INITIAL PEER REVIEW REPORT

REEVALUATION OF MINIMUM FLOWS FOR THE
LITTLE MANATEE RIVER SYSTEM

AGREEMENT NUMBER: 19CN0001936

NOVEMBER 2021

Figure 2-3. Model Grid Overlain onto Aerial Photography

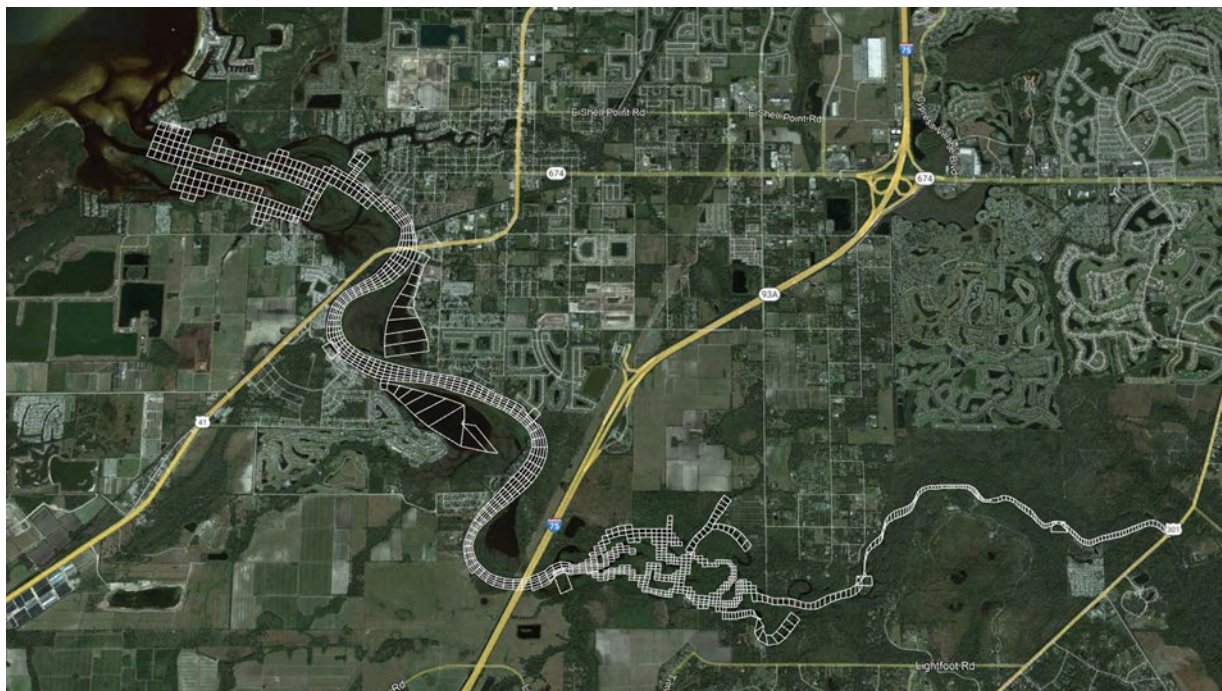
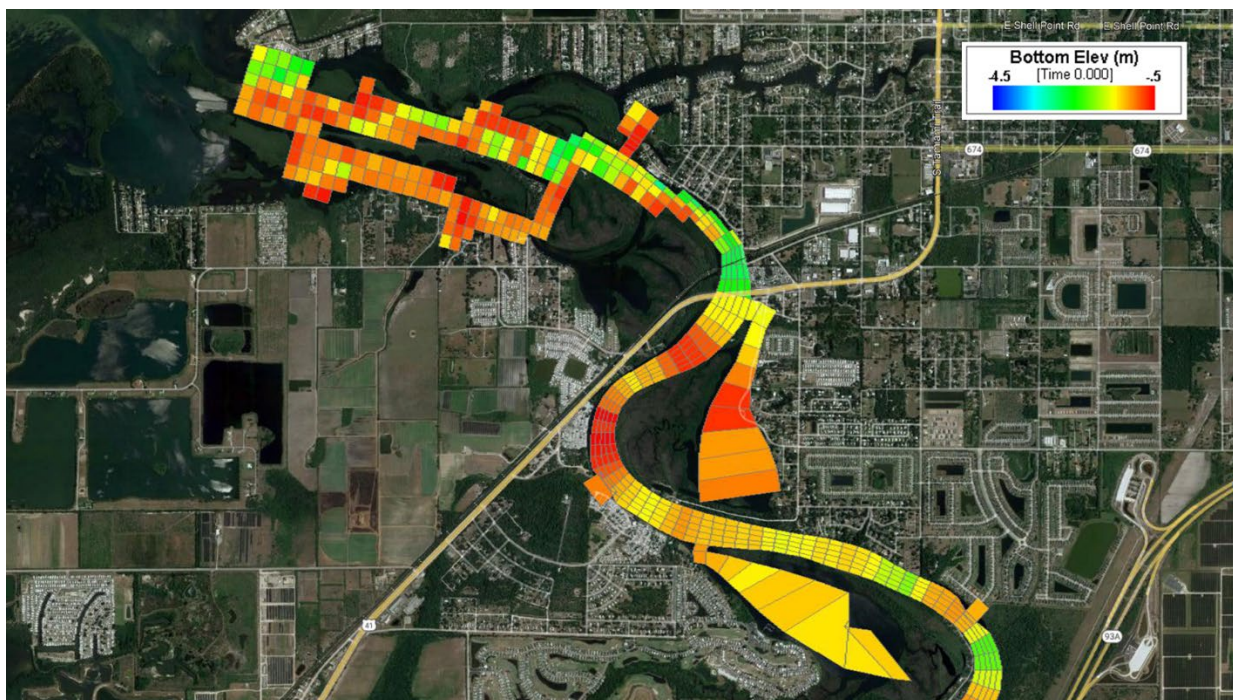
For mechanistic models of this type, a key aspect is that the grid developed provides a reasonable and accurate physical representation of the system. Figure 2-3 presents the EFDC model grid overlain onto an aerial of the estuarine portion of the Little Manatee River. The program utilized to transform the available model input files into a representation of the grid in some areas is not completely accurate, but overall, the recreated grid represents what is in the model.

Examination of the grid in relation to the shoreline of today shows areas where the physical representation does not match the actual conditions horizontally. This is especially evident in the area between the mouth up to US 41. This can be seen in the figure as well as in the original grid plots presented within the Huang and Liu report. In this area the sinuosity of the channel is not represented. Upstream of US 41 while the grid does generally follow the primary river channel, the grids extend outside of the channel into tidal marsh areas and in some instances upland areas. Figure 2-4 presents the depths as represented in the model. Examination of this figure identifies that the model, in a number of areas, is flat across the cross sections with no true channel geometry defined. This is most likely not an accurate representation of the overall system geometry.

One aspect of the model is that there is no wetting and drying being simulated. Examination of the model input files indicates this function is turned off. Wetting and drying is where the model simulates areas of tidal marsh that flood and drain throughout the tidal cycle. Examination of the aerial photographs indicates there are potentially significant areas of tidal marsh adjacent to the system. While the model does include some side storage areas, it would appear that overall, a number of areas are not being simulated. This would relate to the accuracy of the tidal prism being simulated.

Recommendation:

The model is utilized to calculate area and volume changes, so an analysis should be conducted to provide a comparison of the model areas and volumes with the actual volumes and areas in the system. A recommendation would be to calculate the longitudinal cumulative volume and area from the river mouth in the model (by river mile) up to US 301 versus actual inundated volume and area calculated from available shoreline, light detection and ranging (LiDAR), and bathymetric data. This should include adjacent tributaries as well as potential areas for flooding and drying in the adjacent marsh areas.

Figure 2-5: Measured Surface and Bottom Salinity Boundary Condition

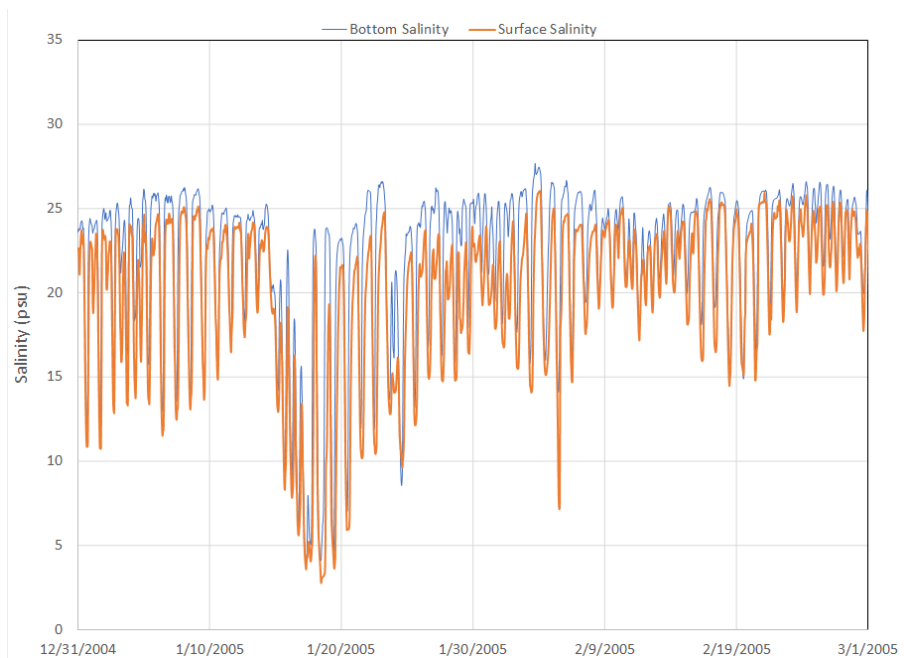
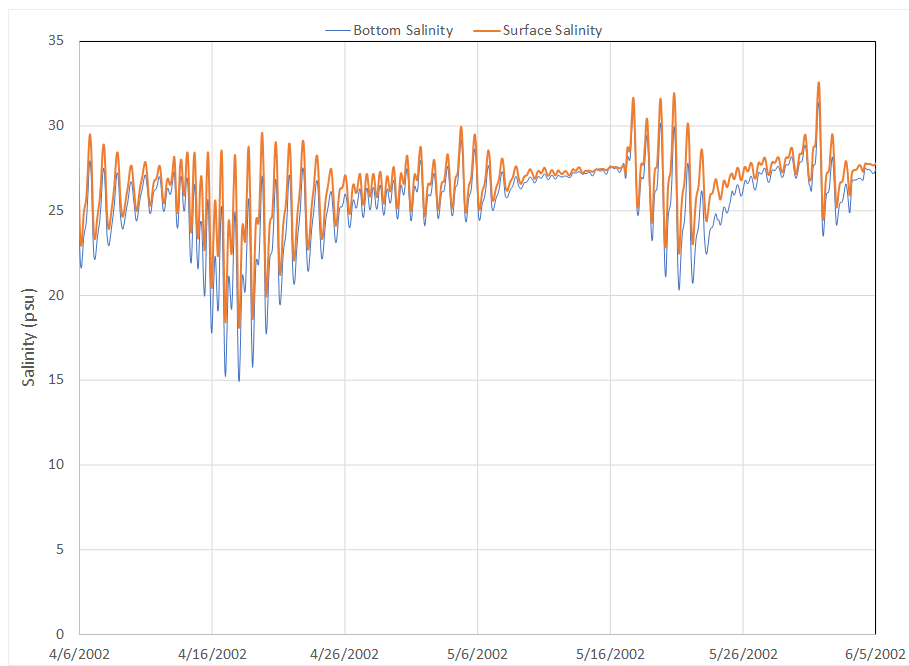
For the MFL baseline run and the flow reduction runs it was determined that the boundary conditions in the model are a mixture of measured data (for the period from around march 2004 through 2005) and data generated from regressions developed by HSW. This was not documented in any of the supporting materials. Figure 2-5 presents a plot of the surface and bottom salinities for 60 days where the measured data were utilized. Figure 2-6 presents a plot of the surface and bottom salinities where the boundaries were derived from the HSW regression. Examination of the plots shows two things. First, it appears for the boundaries created using the HSW regression, an error was made and the bottom and surface salinities appear to have been flipped. Second, the overall behavior of the boundary in the regressed condition does appear to match that seen in the measured data. It should be noted that for the MFL the HSW regressions were updated and per the documentation provided improved.

Recommendations: Runs should be performed to determine if the error is fixed if it would change the results of the simulations. It is likely that this error will not have a significant impact on the overall calculations due to the generally small degree of stratification in the system, but the District must determine the defensibility of carrying this error forward if the

analyses are not fully redone with the fixed boundary condition. Additionally, the regression utilized for the generation of the boundary conditions should be utilized to calculate the boundary condition during the period of the measured data and the two compared. This will allow for an assessment of the reasonableness of the created boundary for MFL determination.

Figure 2-11. Area of Inundated Vegetation (green) as a Function of the Percentile Flow at the USGS Wimauma Gage. USGS flow gages are shown as red triangles. From Janicki Environmental, Inc., 2016.

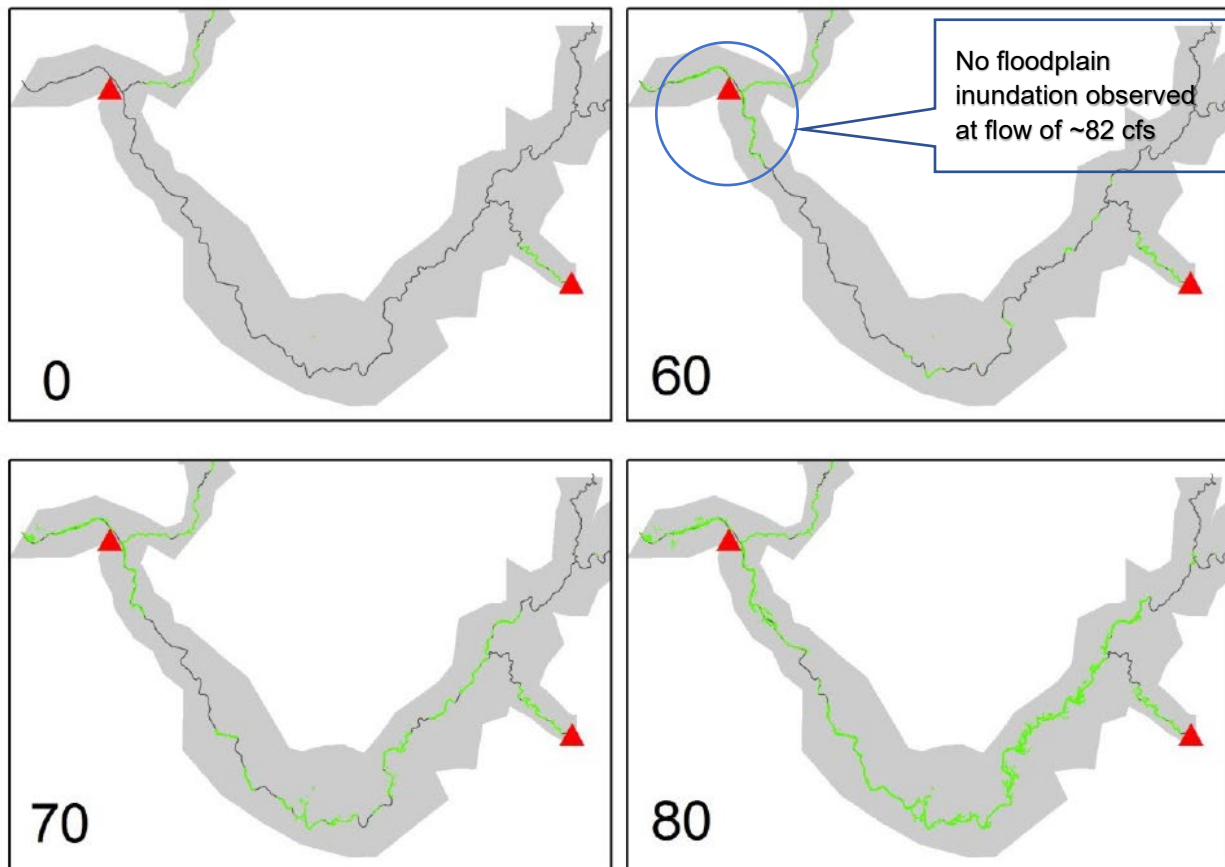
Janicki Environmental, Inc. (2016) referred to the above figure this way: “This example demonstrates that the floodplain generally does not become inundated until flows are above the 70th percentile (i.e. 110 cfs) though small pockets of wetlands are inundated with flows as low as the 60th percentile (72cfs).” It is not clear from the supporting documentation if this analysis considered channel bank elevations, or only the elevations within the floodplain. There undoubtedly are low areas within the floodplain that are lower than the adjoining riverbank elevations and are therefore hydraulically isolated river until the stage exceeds its banks.

Furthermore, during field observations conducted on October 15, 2021, flow at the USGS Wimauma gage was about 82 cfs, which would be within proposed block 3. Field observations were conducted at several locations, including the entire area along the main river channel circled in blue in Figure 2-11. No floodplain inundation was observed at any of the visited locations. Flows were fully contained within the banks with significant freeboard suggesting much higher flows would be needed to inundate the floodplain. This raises the question of whether the 60th percentile flow (72 cfs) is properly supported as a high-flow threshold.
